Remarks:

Appl. No. 09/854,362
Amdt. Dated March 18, 2004

Annotated Sheet Showing Changes

FIG. 1a

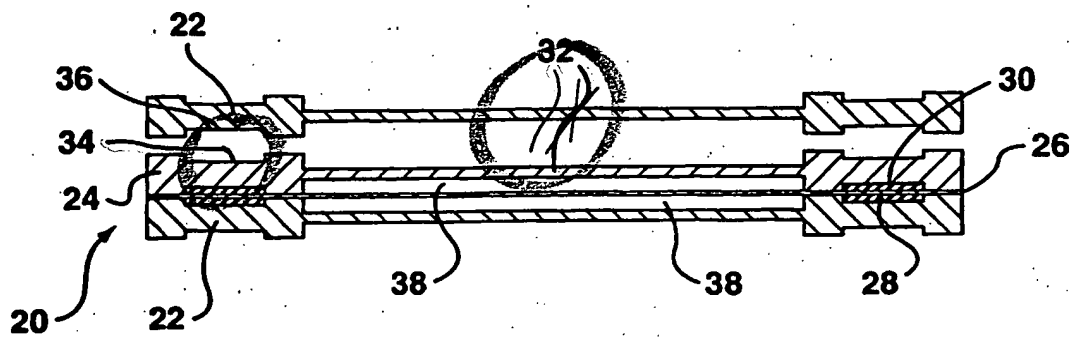
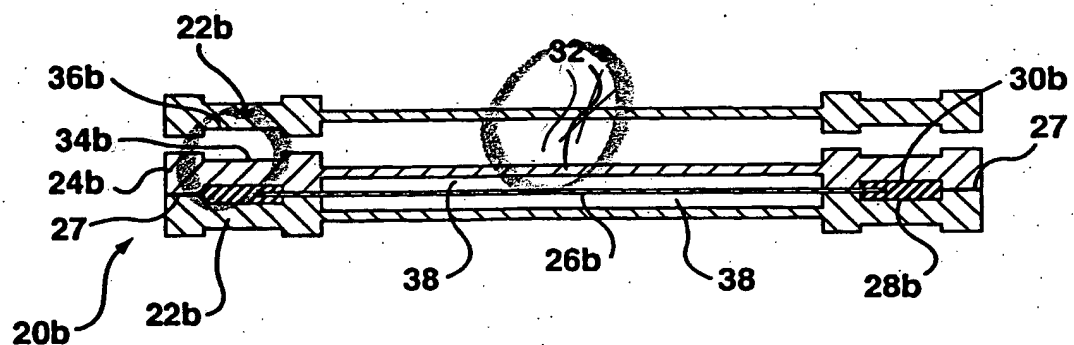
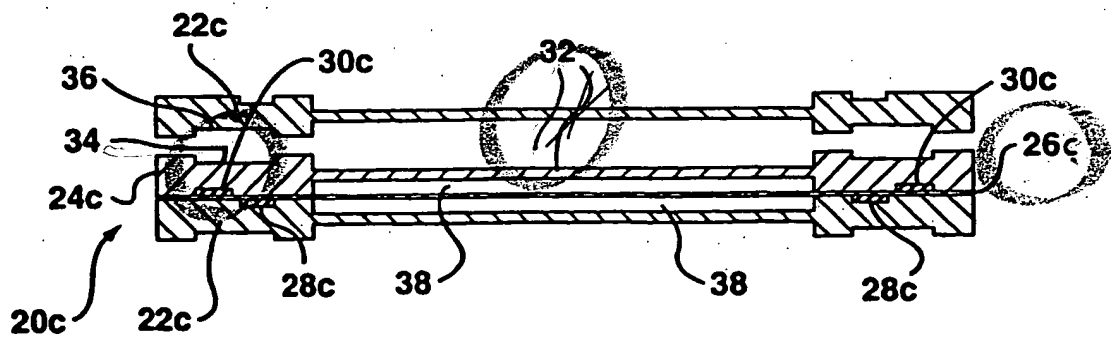
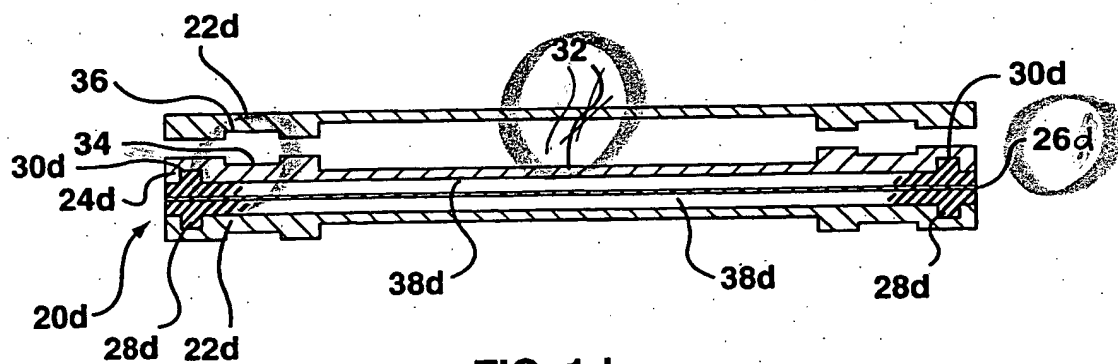
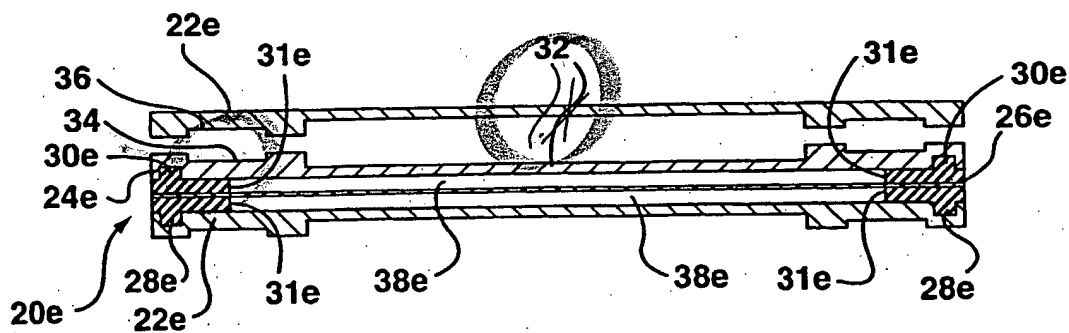
With respect to the drawings, it will be understood that the amendments to the

lead lines in Figures 1 and 2 are intended merely to ensure that these drawings are wholly consistent with the specification and to aid in understanding the drawings.
